U.S. Department of the Interior BUREAU OF LAND MANAGEMENT Sundry Print Repor

Well Name: HUERFANO UNIT Well Location: T26N / R9W / SEC 35 /

Type of Submission: Notice of Intent Type of Action: Plug and Abandonment

#### HILCORP ENERGY COMPANY HUERFANO UNIT 307 P&A NOI

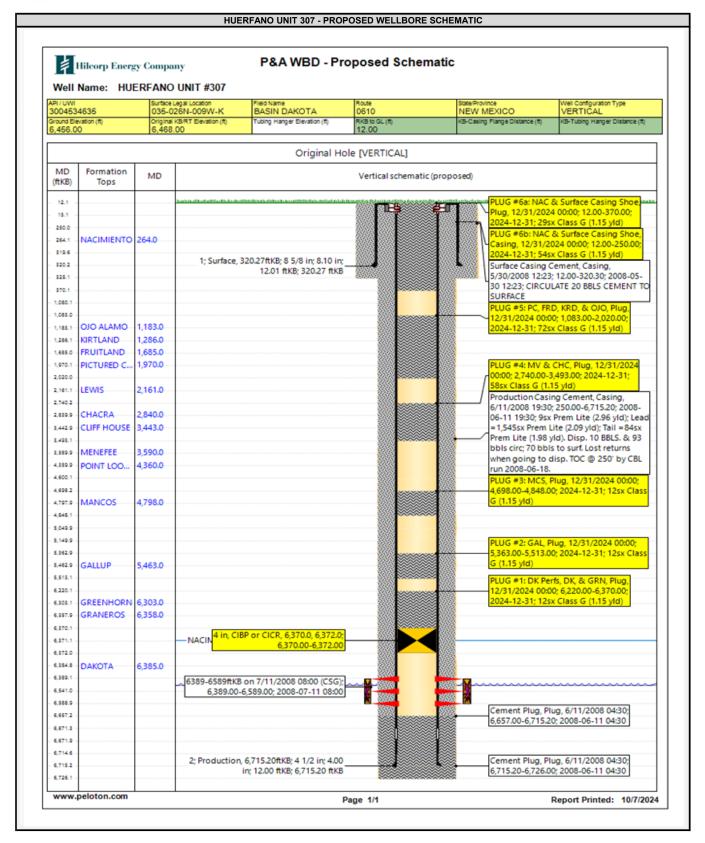
- Vertical wellbore all fm. tops are TVD.
- -Modify the Plug 1 TOC to 6242' to account for the BLM geologist's pick for the Graneros.
- -Modify the Plug 2 TOC to 5447' and the BOC to 5597'to account for the BLM geologist's pick for the Gallup.
- -Modify the Plug 3 TOC to 4542' and the BOC to 4702' to account for the BLM geologist's pick for the Mancos.
- -Divide Plug 4 into two plugs to account for the BLM geologist's picks for the Cliff House and upper Chacra. Cover the Cliff House from 3572' to 3422'. Cover the upper Chacra from 2837' to 2687'.
- -Modify the Plug 5 TOC to 927' to account for the BLM geologist's pick for the Ojo Alamo.
